PLANNING REPORT

PLANNING AND ZONING COMMISSION

AUGUST 6, 2009

1. **Perimeter Center, Subarea I – Crown Mercedes** **6350 Perimeter Loop Road**
09-053AFDP **Amended Final Development Plan**

PROPOSED MODIFICATIONS CROWN MERCEDES DEALERSHIP

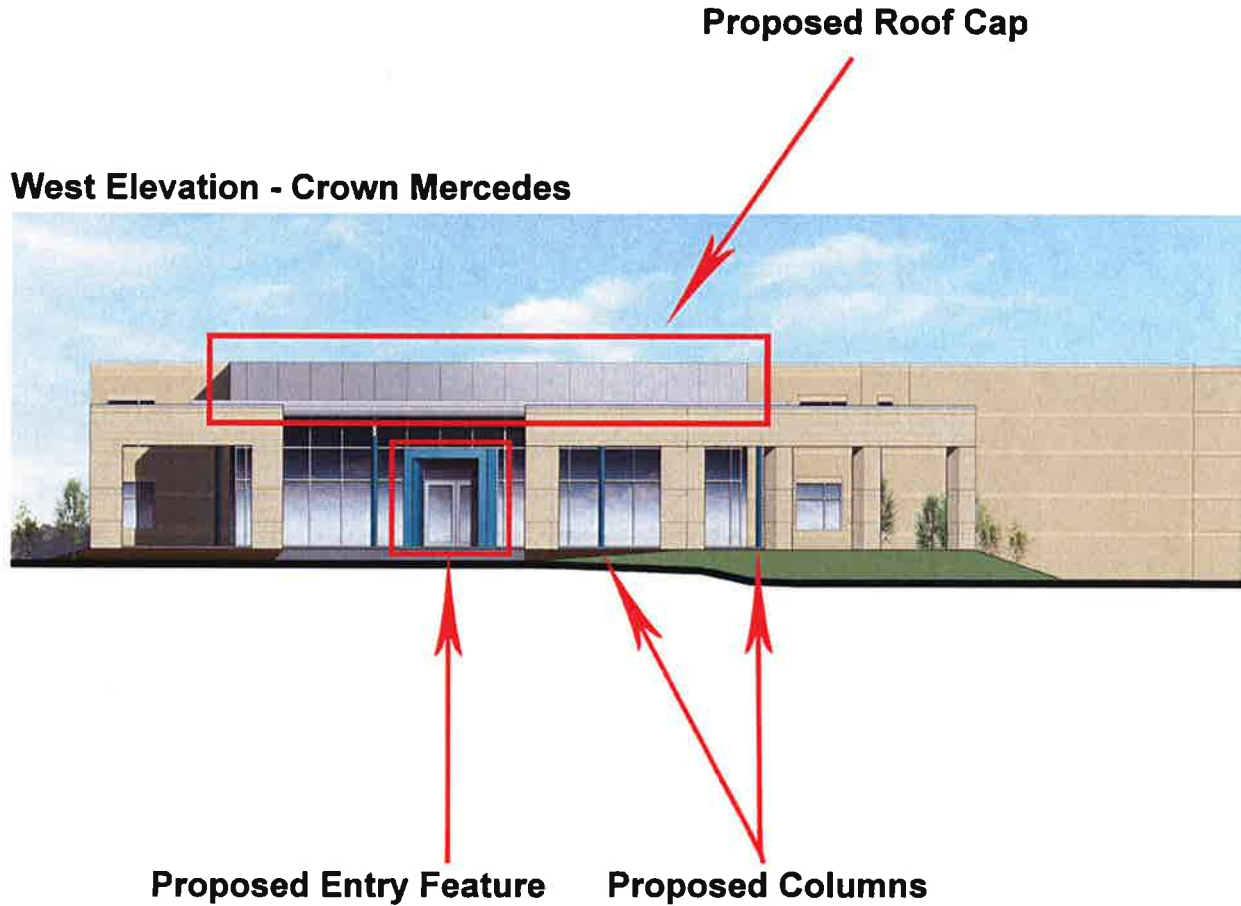
The applicant is proposing to install a light blue (SW6529 “Scanda”) EIFS entry feature over the existing doorway on the west building elevation. Seven blue columns (Matthews Paint “Cobalt Blue”) with three-finned silver capitals (Matthews Paint “Silver Metallic”) are proposed in front of the existing storefront windows on the north, west, and south sides of the building. The proposal also includes a modification to the roof line, with a silver roof edging and decorative silver paneling (Alucobond “Silver Metallic”) roof cap.

The development text states that all buildings shall be designed to reflect the architectural quality and coordination between existing development in Subarea I and the surrounding area. It is Planning’s opinion that the proposed modifications are consistent with the existing contemporary character of the development; however, because two additional shades of blue are proposed, Planning recommends that the blue columns be modified to match the color used for the monument sign faces to reinforce the consistent character of the Crown campus.

Criteria met with condition. The proposal conforms to the approved preliminary development plan and all other applicable zoning text and Code requirements. In order to coordinate with the Crown dealership campus, Planning recommends that the blue columns proposed for the Mercedes Benz facility utilize the same color as the existing blue monument sign faces (Pantone 3025C) to reinforce the campus-like feel of the three dealerships (Condition).

That the blue columns for the Mercedes Benz facility utilize the same color of blue (Pantone 3025C) as the monument sign faces.
